To:
Cc:
Bcc:
Subject: 薄扶林居民對於香港大學擬在沙宣道以東綠化帶興建大型實驗室的反對
From: Anita FM SIT/LEGCO - Monday 20/09/2021 09:38

立法會FC238/20-21(01)號文件
LC Paper No. FC238/20-21(01)

Update on Progress Report - HKU Development (Southern District) 發展項目進展 - 香港大學南區發展項目

OBJECTION STATEMENT
S.12A Rezoning Application No. Y/H10/13
Proposed Rezoning of “Green Belt” (“GB”) Site to “Government, Institution or Community”
(“G/IC”) on the Approved Pok Fu Lam Outline Zoning Plan No. S/H10/19 (OZP)
for the New Academic Building (the Proposal) of The University of Hong Kong (HKU)
Government Land to the East of No. 3 Sassoon Road, Pok Fu Lam (the Site)

Figure 1 Location and Zonal Context of the Application Site (extract from the OZP)

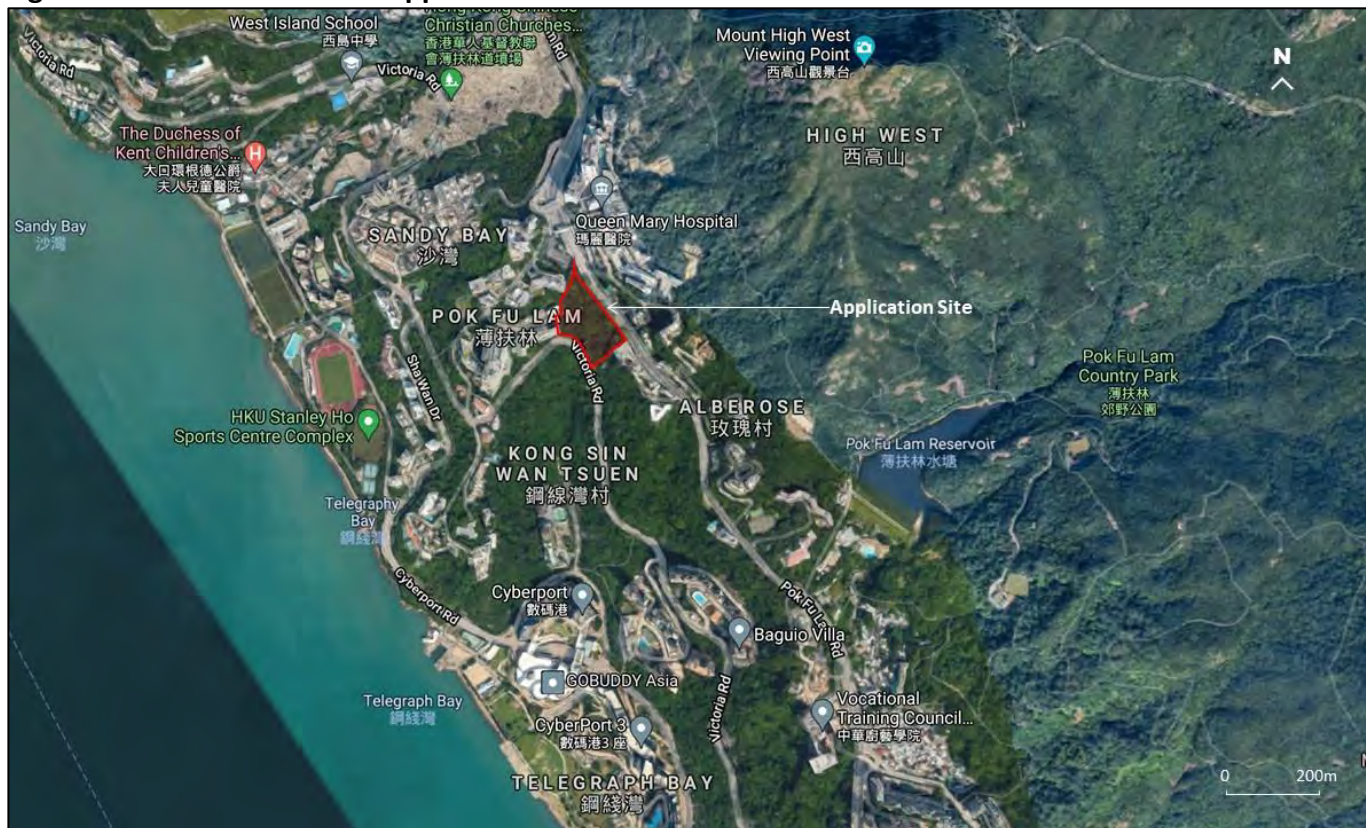
- 1.5 Reference is made to the extract of the OZP showing the location of the Site in **Figure 1** and the aerial photograph in **Figure 2** below. This “GB” buffer where the Site is located is the only remaining opening that was originally intended to serve as a breathing space with the natural assets in Pok Fu Lam. The government must have considered the “GB” zoning very carefully and the OZP has made it clear the “GB” zone is important to the whole area and the government must minimise the reduction of the “GB” zoning.

Figure 6 Blockage of the Only Window for Wind Penetration

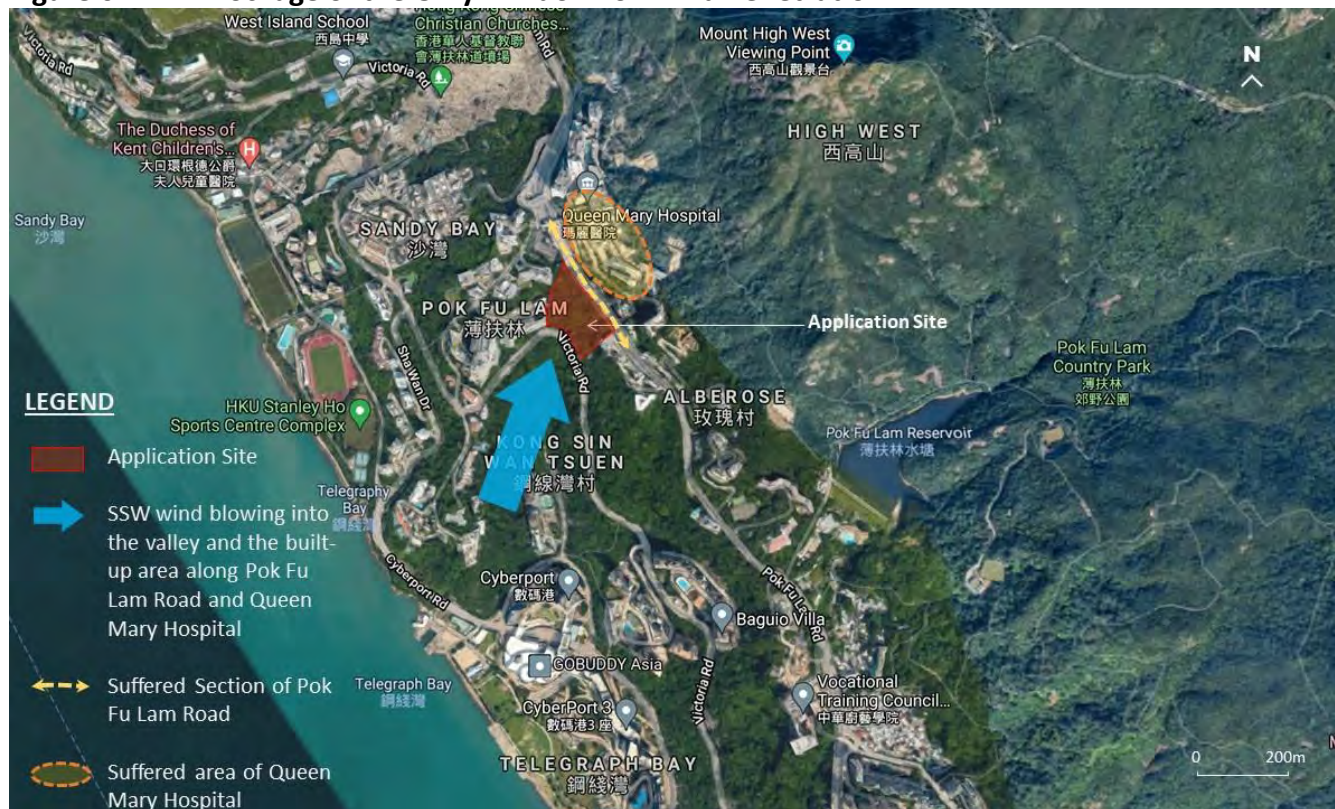
- 3.1 The Site is located in an opening between HKU's new academic building at No. 3 Sassoon Road that is under construction and the Ebenezer School (**Figure 1** on p.3 above refers). Filling up this breathing space would block the only remaining opening from the seaward side from the southwest (SW) and southwest-southerly (SSW) to the built-up cluster in the northeast (NE), diminishing the air ventilation into the built-up cluster, along Pok Fu Lam Road, and the surrounding environment including

QMH. It should be noted that the applicant has failed to provide any schematic design on what the elevated structures will look like when viewed from Pok Fu Lam Road, or provide any information on how the elevated structures on Pok Fu Lam Road will extend the tunnel effect that exists right now between Ebenezer School and Radcliffe, where there is already restricted air movement. The erection of the proposed blocks of new buildings on Pok Fu Lam Road are aggravating the tunnel effect.

- 3.2 The Air Ventilation Evaluation (Expert Evaluation) (AVA EE) conducted by the applicant has focused on the obstruction on the proposed development. However, the AVA EE has not taken into account the impact caused by the proposed bulk of the building at the Site on the surrounding area.

- 3.3 Moreover, the AVA EE stated that the Site is anticipated to have a better wind environment without obstruction, and the incoming SSW and S winds from the sea would have no obstruction into the assessment area and the Project Site (para. 6.7.9 of the applicant's planning statement refers). The following plan shows the obstruction of the summer prevailing wind SSW by the proposed new academic building at the Site. The pedestrians on Pok Fu Lam Road and all the residents and visitors in the area including those in QMH are going to suffer from the blockage of air circulation by the proposed new academic building.

Figure 11 Location of Photos 5 and 6 Taken from QMH

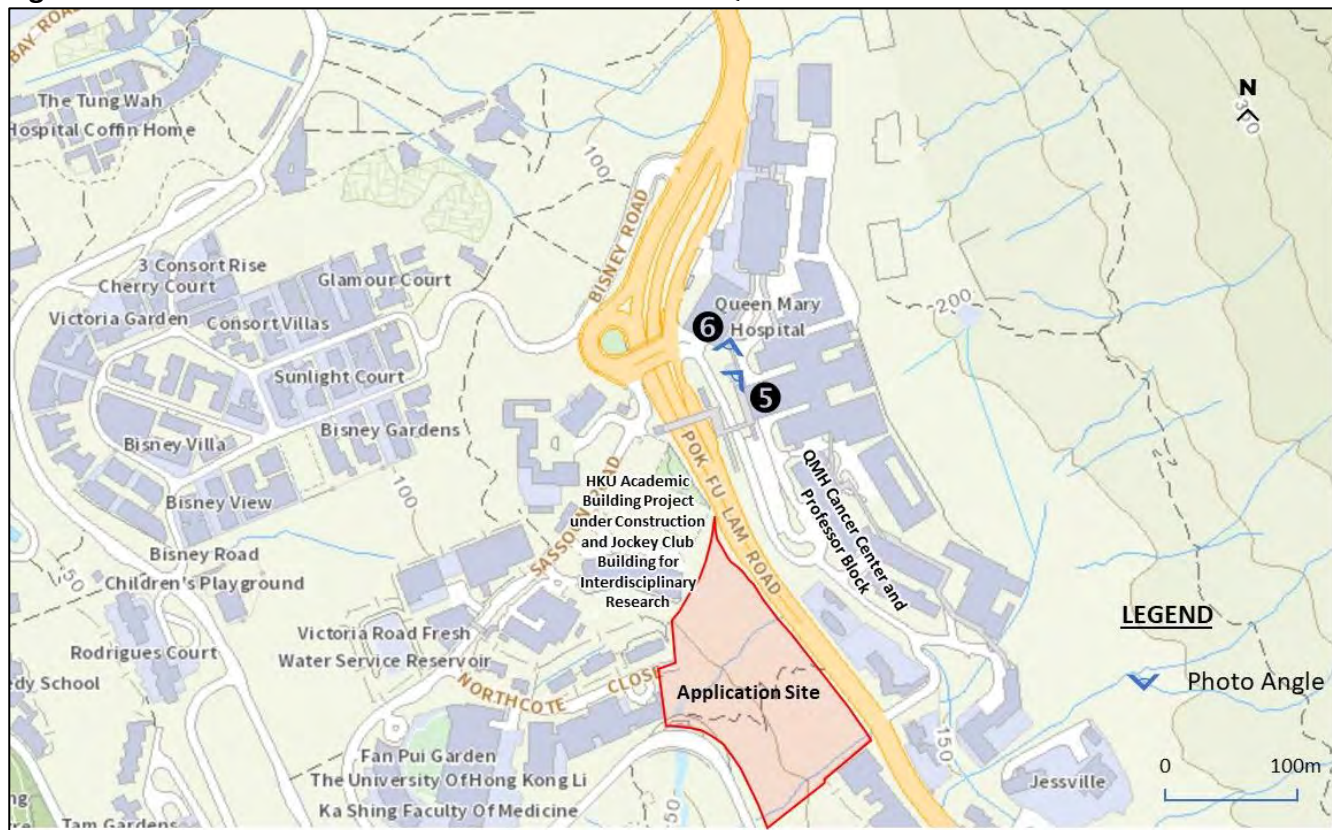
- 3.5 If the applicant's rezoning request were approved, the proposed development together with HKU's adjacent No. 3 Sassoon Road project would block the only remaining opening of wind penetration from the sea and create the highly undesirable impermeable wall effect which would significantly degrade the environment in this area of Pok Fu Lam. According to the Hong Kong Planning Standards and Guidelines (HKPSG) (Chapter 11 on the Urban Design Guidelines), breezeway along major prevailing wind directions and air paths should be provided in order to allow effective air movements into the urban area to remove heat, gases and particulates, and to improve the micro-climate of the urban environment. The urban air ventilation is in particular vital for QMH and Pok Fu Lam Road. The current breezeway is facilitated by the "GB" buffer at the rezoning site and the valley amidst Pok Fu Lam Road and Victoria Road (**Figure 6 to Figure 13** above refer). However, the Proposal is in contrary to the above government's commitment in preventing the impermeable walled environment. The applicant's rezoning request should therefore be rejected.

Figure 14 Section View of the Proposal from Victoria Road

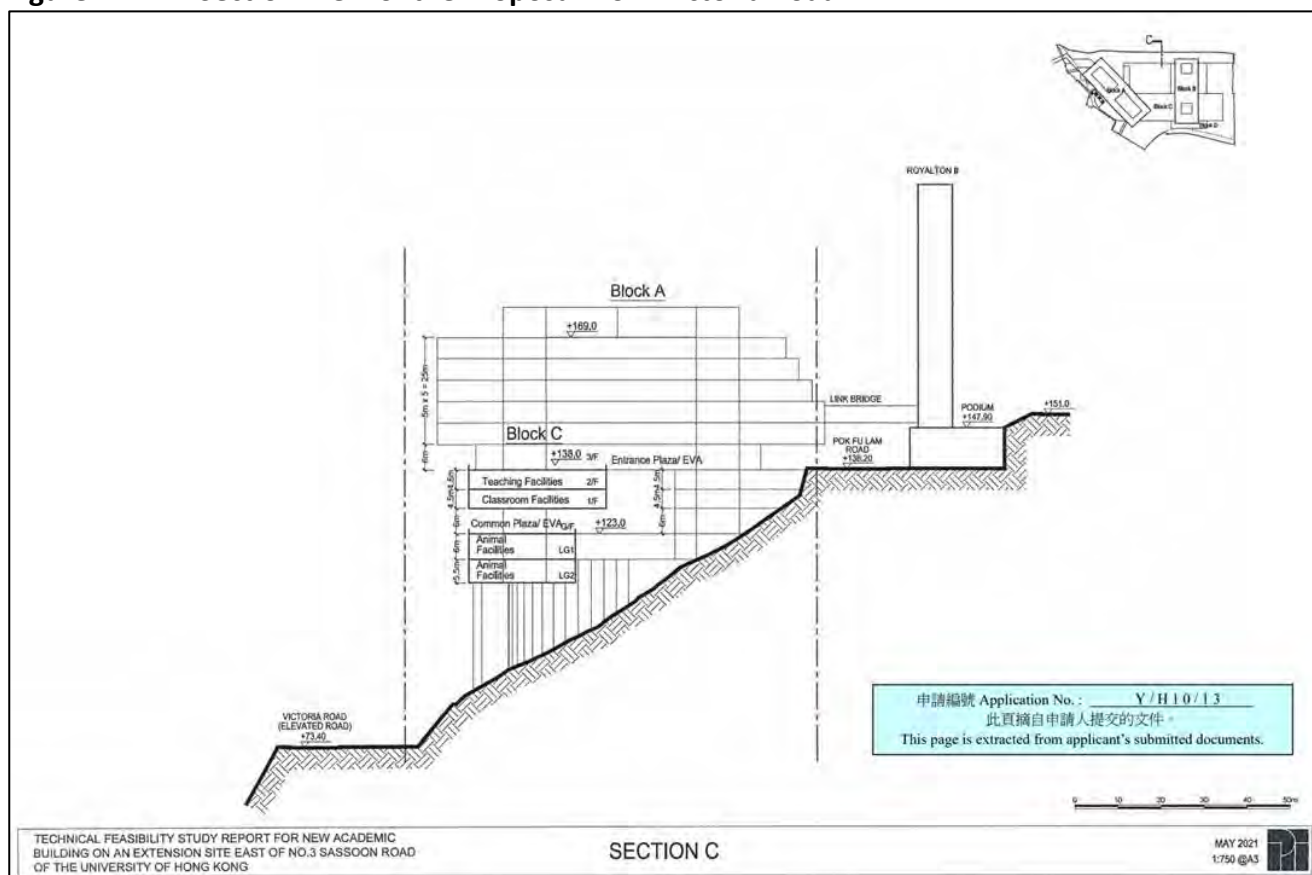
- 6.1.1 It is evident that the proposed development, which has a maximum height of 169mPD and involving over 1.6 Ha of land filling up the "GB" buffer in between the HKU academic building under construction (No. 3 Sassoon Road) and the Ebenezer School to the south-east, would irrevocably change the existing green character and low density in this locality and create the highly undesirable wind blockage as detailed in paragraph 3 above. The Proposal is therefore contrary to the government's commitment in improving the wind environment in our city as set out in the HKPSG.

- 6.1.2 The proposed new building is large in scale involving the need of ***excavation into the vegetation 8,000m² down to 10m in depth***. This is irrevocably destroying the vegetation and ecosystem in this "GB" buffer. The difficult terrain has also proved the scheme on the Site undesirable. **Figure 14** below shows the bulk of the proposed buildings and the massive column structures at Victoria Road. The fundamental problem is due to the difficult topography. The TPB is requested to carry out a critical review of the applicant's rezoning request on the balance between the disturbance on this piece of natural vegetation and possible alternative sites that may involve lesser extent of destruction to the natural environment.

Figure 15 **Proposed Development Scheme Showing the Land-Take of the Ramp and the Building Structure at LG2/F**

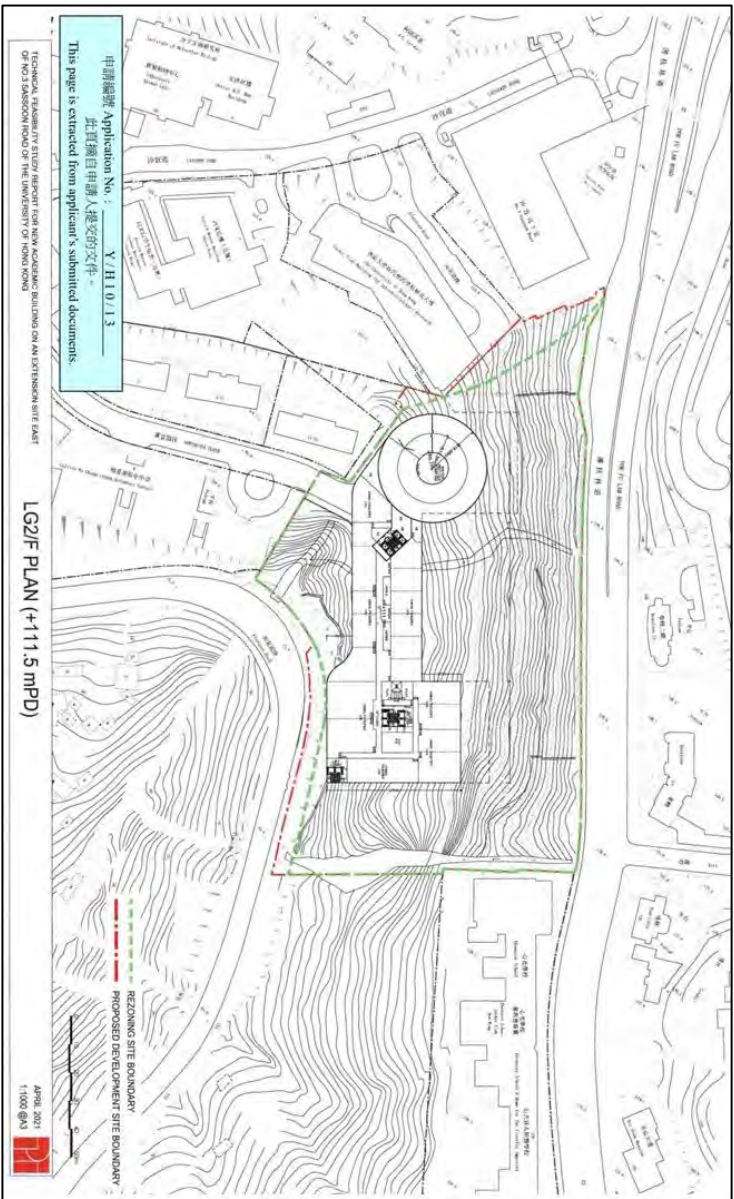
6.2.1 The proposed building layout on this piece of “GB” buffer of difficult terrain is inefficient and unnecessary. Instead of choosing an alternative site with much less steep/difficult topography or building down rather than up (i.e. constructing simple blocks of building at the level of Victoria Road instead of having elevating columns to support structures above Pok Fu Lam Road), such proposed building layout would require the construction of **intrusive elevated columns and unnecessary ramps** taking up extensive land area and destroying the natural vegetation. Only a component of the ramp is taking up an area of about 1,255m² and additional land would be required for other related accesses for the proposed development. A critical review on the efficiency of the applicant’s proposed building layout when compared to more appropriate and efficient construction plan at alternative location has to be carried out as part of the TPB’s review of the applicant’s rezoning request.

Figure 17 Location of Photos 7 to 9 Taken from QMH

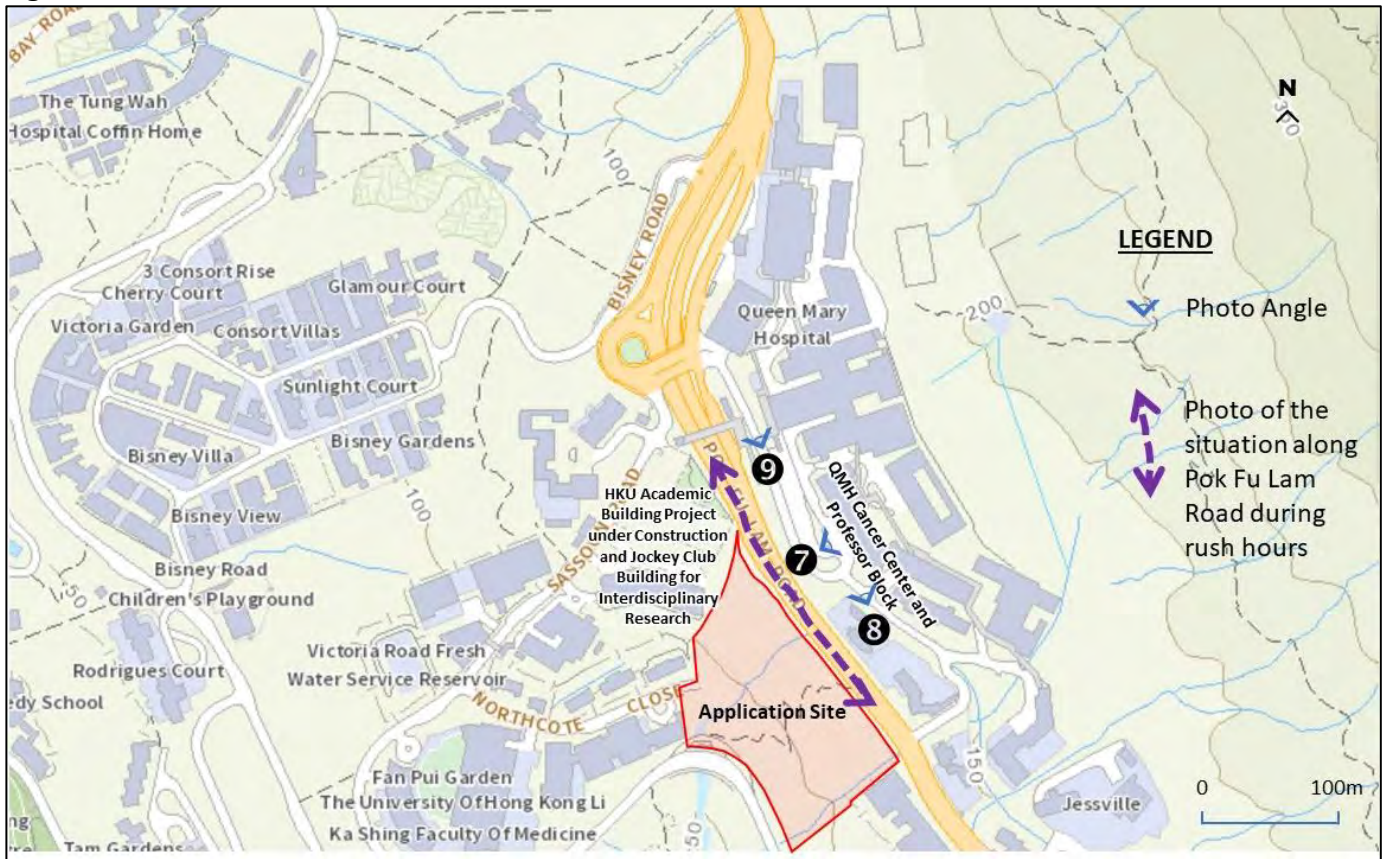
- 7.3 Traffic along Pok Fu Lam Road is already very congested during rush hours. Traffic along Sassoon Road and within QMH is also an issue given it is narrow, steep and winded. **Photos 7 to 9** below show the traffic situation within QMH at different times of the day, and the traffic queue tailing back to the hospital at the junction with Pok Fu Lam Road. In emergency situations for ambulance and required attendance by the Fire Services Department, road blockage due to inadequate vehicular access is common.

Figure 22 Indicative Location of the Possible Alternative Sites in Pok Fu Lam

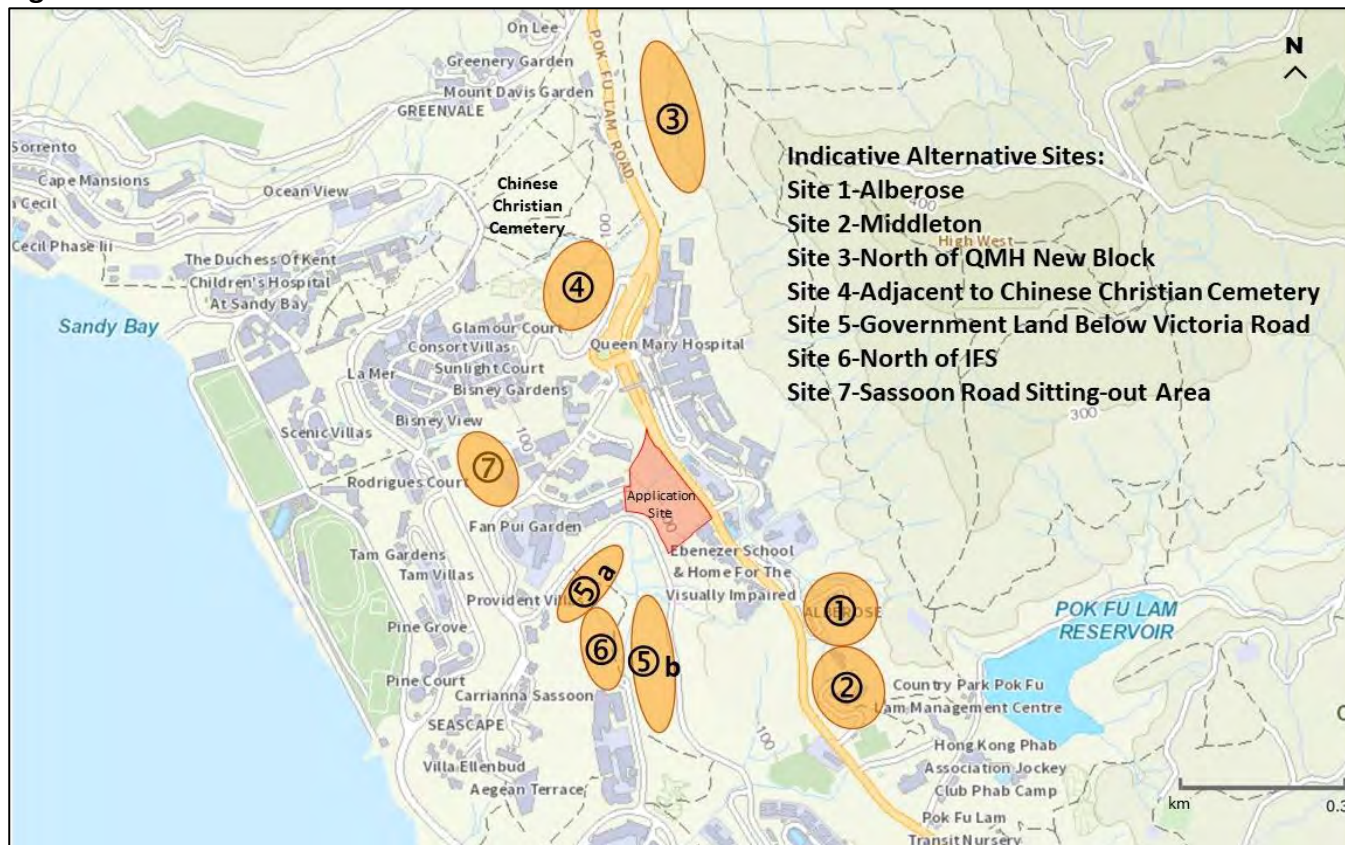
- 9.11 There is insufficient information in the submission to demonstrate the locational criteria for the provision of the research laboratories at the Site in proximity to QMH. Even if the applicant were able to justify the need for the proposed development to be in proximity to QMH, there are alternative and more appropriate sites in this area of Pok Fu Lam which can serve HKU's needs.
- 9.12 Despite the repeated requests to HKU from the Residents to provide information on the alternative sites that have been studied, there is no such information in the s.12A submission. In the absence of the above, the Residents have provided assistance in identifying possible sites in Pok Fu Lam that would also meet the HKU's Goals. Seven alternative sites have been identified and are indicated in the following figure.

Figure 23 Photo of the Sassoon Road Sitting-out Area at Site 7

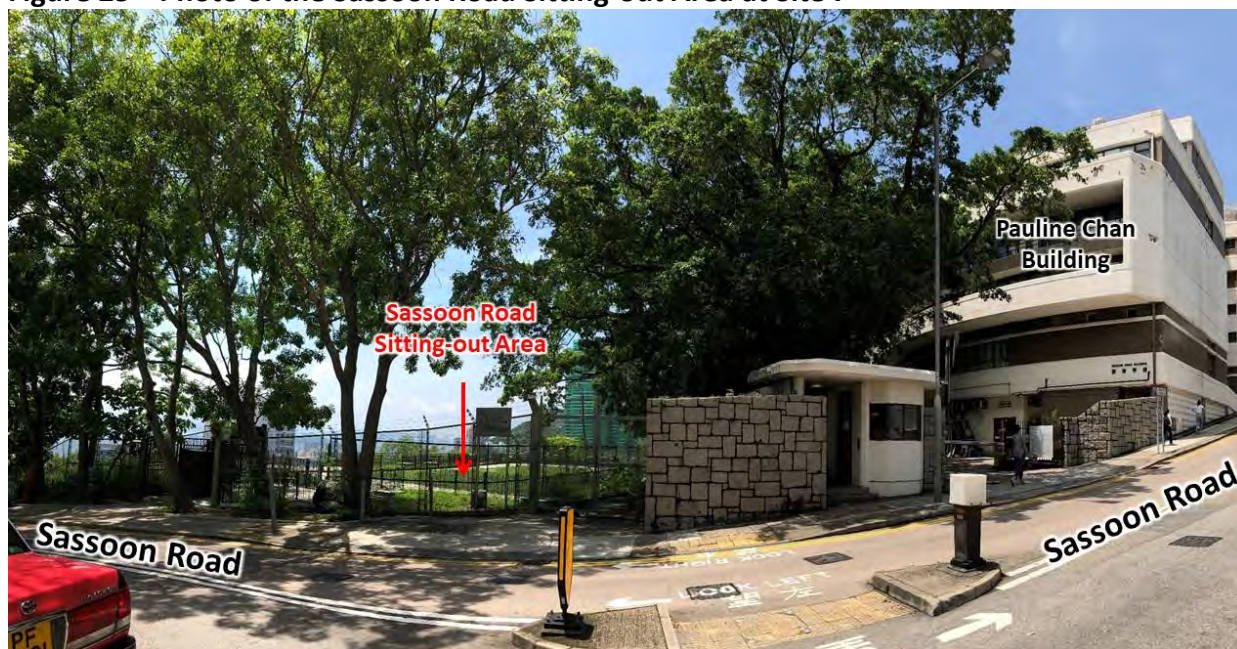
9.20 The Sassoon Road Sitting-out Area atop the Victoria Road Fresh Water Service Reservoir (**Figure 23** below) is currently zoned “G/IC” and its adjacent land area is zoned “GB” on the OZP. The sitting-out area has a low utilisation since its construction. To make better use of the land, this site and its adjacent land area demonstrates potential for the proposed development. This has a better advantage of the flat topography and the area is well connected and compatible with the other campus buildings along Sassoon Road in land use term. This site has been opened up by the Water Supplies Department for recreational use as this site is accessible and not in the vicinity of water treatment works. Given this locational advantage, this site warrants potential for further study of the feasibility for the proposed development.
